Staff Report to the Zoning Administrator

Application Number: **08-0154**

Project Description: Proposal to establish a Montessori school, including swim lessons, in an existing historic building and an accessory structure in three phases for up to 64 students; construct a new parking lot with minor additions including accessibility improvements, an overheight fence along the southern side yard and two identifying signs; and address unpermitted tree removals.

PRELIMINARY GRADING AND DRAINAGE PLAN
SCALE: 1"=20'

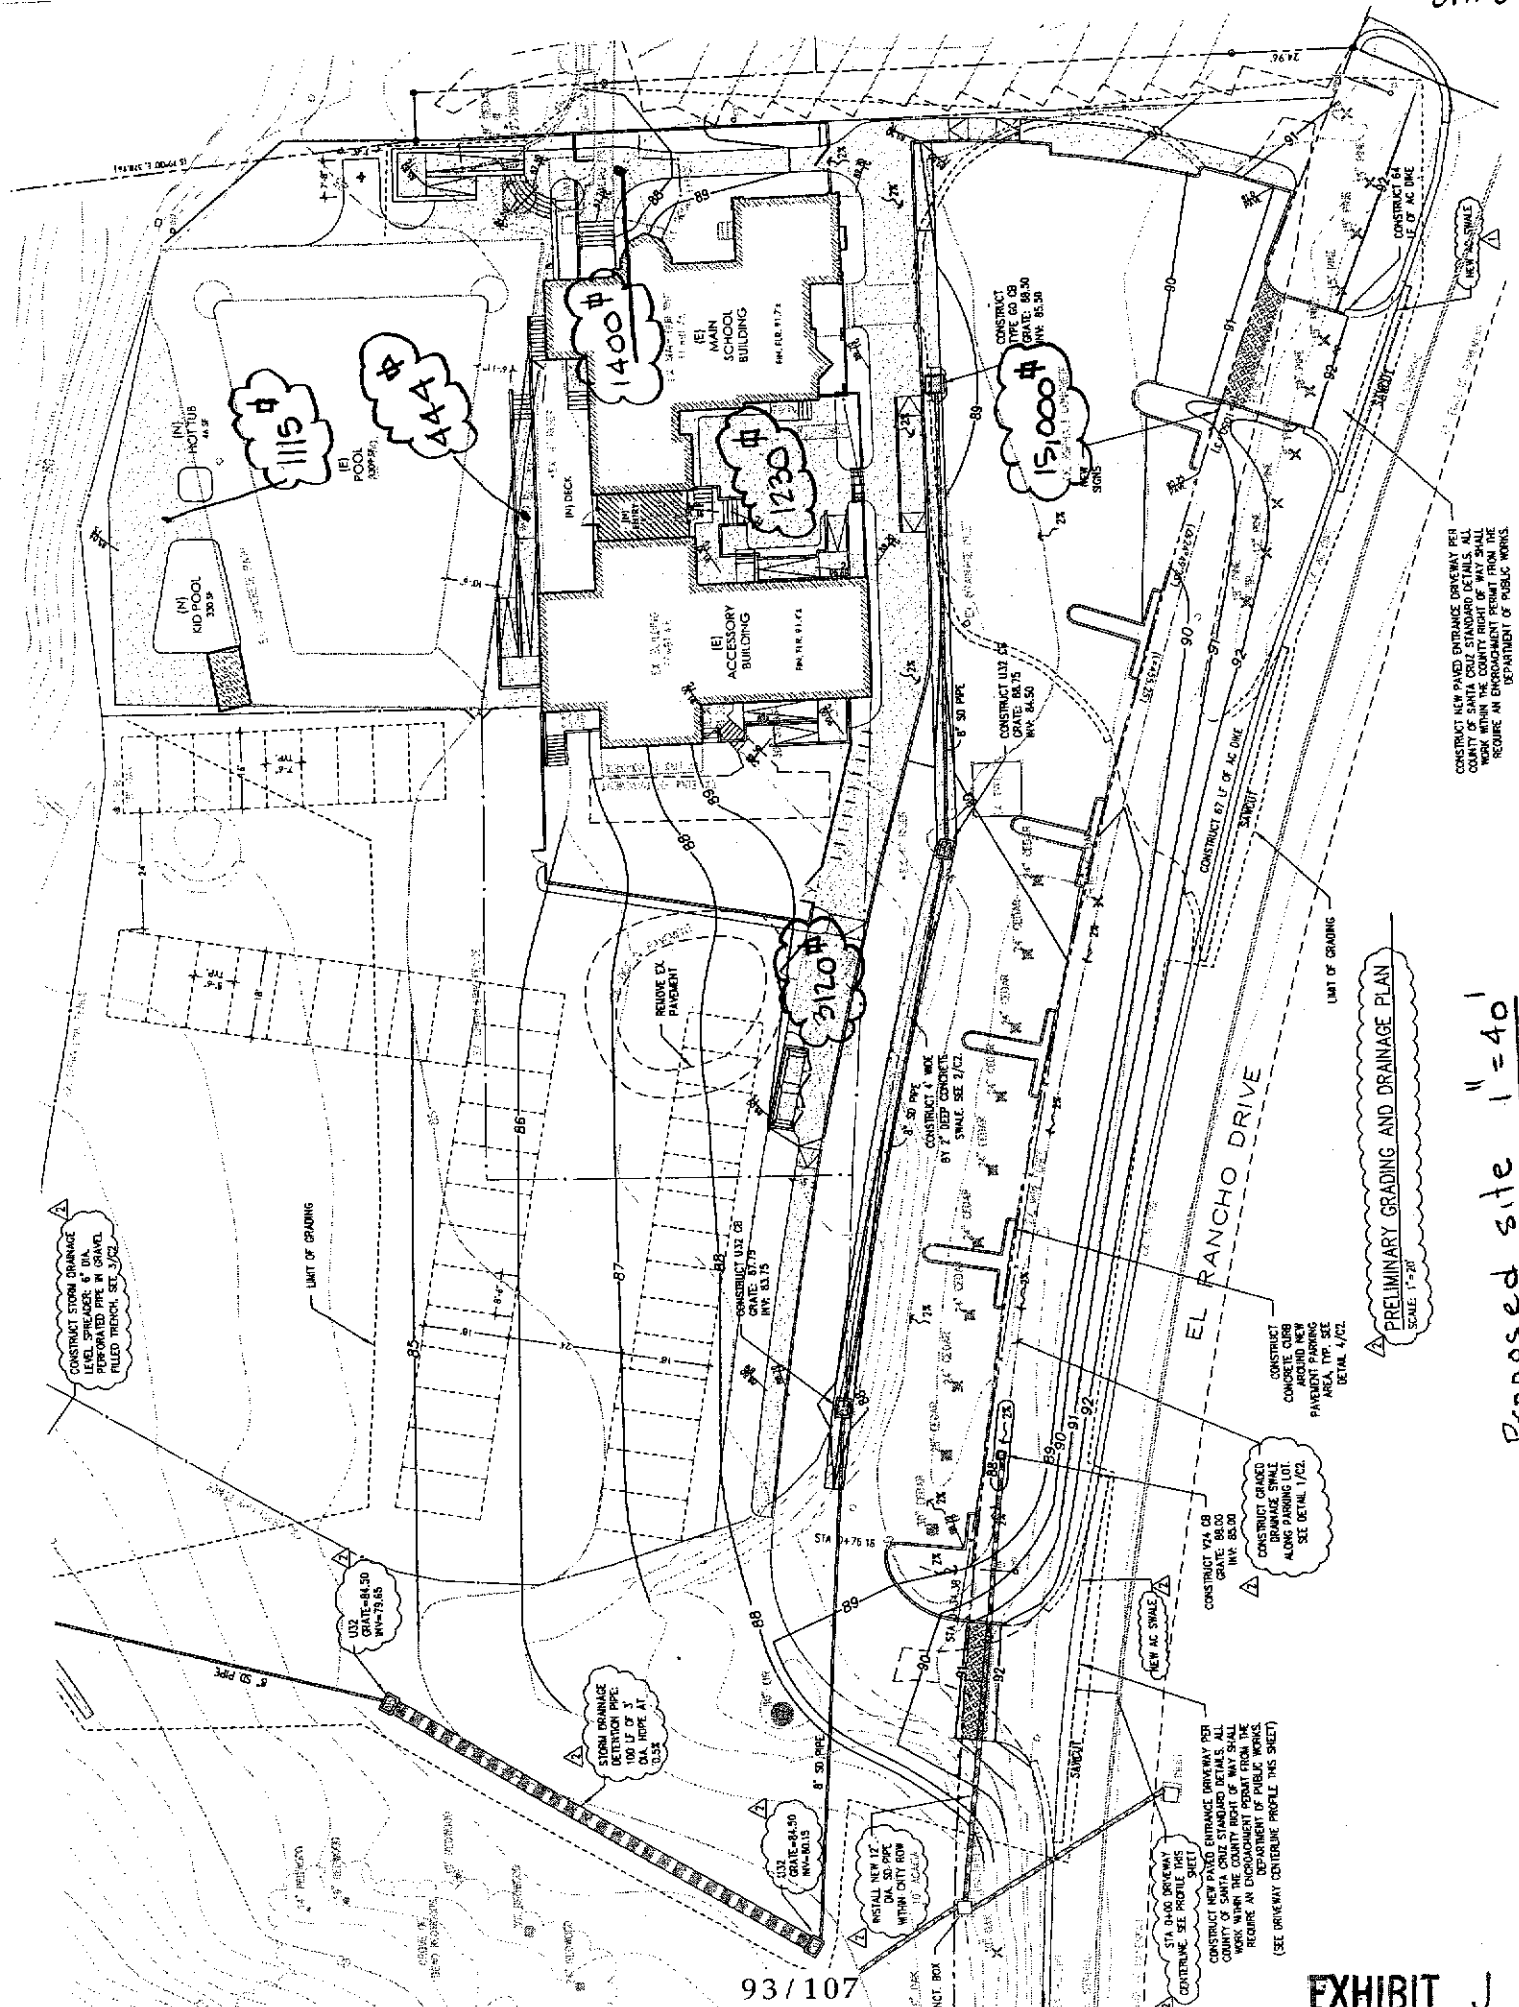
3. Revised grading quantities reflect over 1,000 cubic yards of grading associated with this project. As such, the project requires Environmental Review. Please apply for Environmental Review and provide the appropriate deposit for this service.

4. Please provide calculations for the grading quantities.

5. Please provide top-of-wall and bottom-of-wall elevations for all retaining walls at their beginning, end and transition points.

8. Please show the lateral extents of any required overexcavation and recompaction.

9. Please provide a second cross-section in the east-west direction that extends through the 10-foot fill slope at the rear slope. Also, provide a cross section in the north-south direction that extends through the proposed retaining walls at the northern end of the property. All cross sections should extend a minimum of 25-feet beyond the structure or limit of grading, as appropriate.

It appears that the proposed multi-purpose room and retaining walls at the northern end of the property may not meet the slope setback from descending slopes required by County Code Section 16.20.160. Although structural details are not required at this time, please clarify whether the setbacks can be achieved by providing general foundation information (type of foundation and minimum embedment depth) or showing the proposed foundation depths on the requested cross sections.

1. Indicate on the plans the manner in which building downspouts will be discharged. Proposing downspouts as discharged directly to the storm drain system is generally inconsistent with efforts to hold runoff to pre-development rates.

2. Provide analysis and background information for the proposed percolation structure demonstrating that it meets design criteria requirements for maintaining pre development runoff rates and adequately mitigates for the proposed impervious and semi pervious areas (roof and base rock areas). In addition, site plans shall specify required maintenance procedures to assure the proper functioning of the proposed drainage structure.

4. Please include a cross section construction details for the percolation trench. Details such as rock dimension, trench dimension, etc. in the site plans.

5. Provide a cross section construction detail for the proposed pervious pavement.

7. Provide a cross section construction detail for the proposed graded grass lined swale.

8. Provide additional spot elevations for the proposed concrete side walk(s).

9. Please provide a detail describing how the driveway entrances will conform to existing roadside facilities. Road drainage should not be blocked by the proposed driveway. Provide a typical cross section of the existing road swale and details describing how drainage will be accommodated across/under the proposed driveway.
